Service Bulletin

Bulletin No. 2017-06R1
Jet Drive No. 2017-01R1

2.5L 200 OptiMax SportJet Air Compressor Reed Failure

NOTICE
Revised June 2017. This bulletin supersedes the previous bulletin number 2017-06 March 2017.

Air compressor

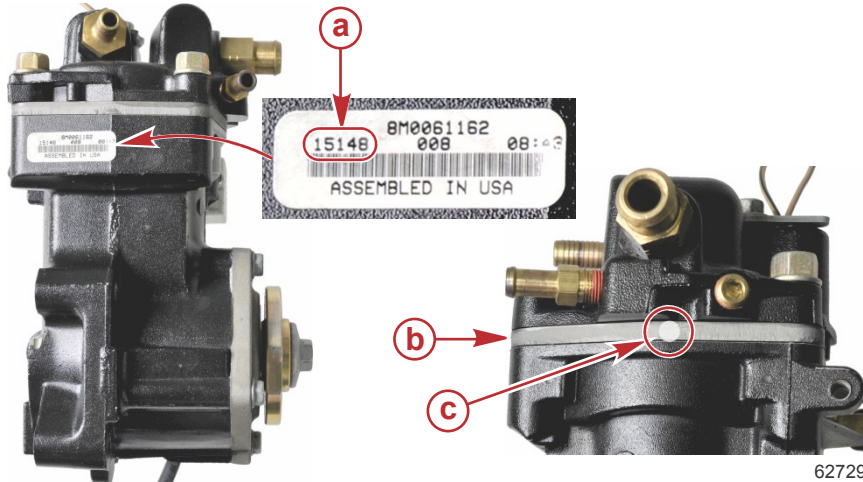
IMPORTANT: A white dot on the edge of the reed plate assembly indicates the reed plate assembly has been replaced. Do not rework a compressor with a white dot on the edge of the reed plate assembly.

Check the engine to confirm whether the air compressor is an affected unit. If no white dot is present and the engine serial number falls within the range specified at the top of this service bulletin, replace the reed plate assembly.

Inspect all in-stock replacement air compressors. If no white dot is present and the Julian date code falls between 14189 (July 8, 2014) and 16246 (September 2, 2016), inclusive, replace the reed plate assembly.

- a** - Julian date code; codes 14189 through 16246 are affected
- b** - Reed plate assembly
- c** - White dot indicating that the reed plate assembly has been replaced and is not affected

Reed plate assembly

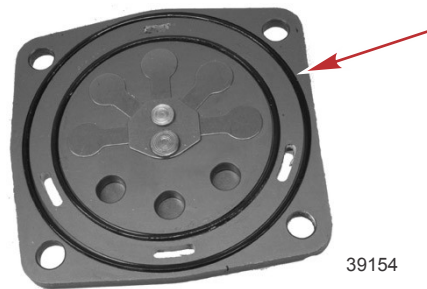
Qty	Description	Part Number
1	Reed plate assembly	835088A10

Port Fuel Rail Disengagement

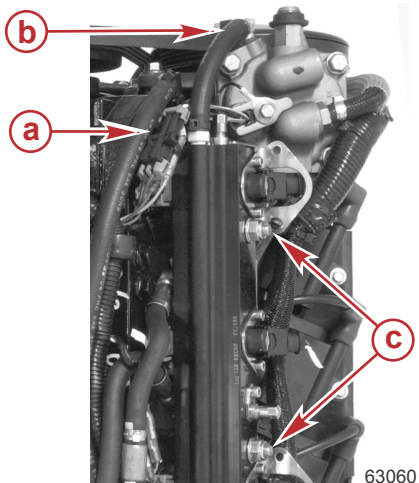
In order to access the lower left-hand screw on the air compressor cylinder head on 2.5L models, the port fuel rail must be temporarily disengaged and moved out of the way.

1. Disconnect the cylinder head temperature sensor harness connector.
2. Disconnect the compressor water inlet hose.

3. Remove the two fuel rail mounting nuts.

- a - Cylinder head temperature sensor harness connector
- b - Compressor water inlet hose
- c - Fuel rail mounting nuts (2)

4. Position the fuel rail out of the way, and complete the reed plate assembly replacement.

Before putting the engine back into service, be certain to reconnect all items and tighten the fuel rail mounting nuts to the specified torque.

Reed plate assembly edge marked with a white dot

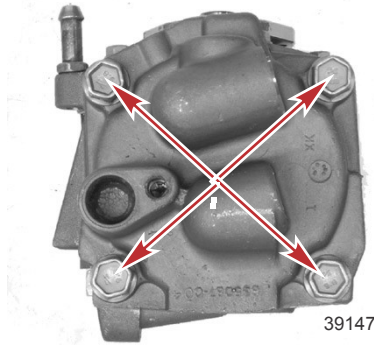
- To indicate that the rework procedure has been completed, mark the top edge of the replacement reed plate assembly with a white dot.
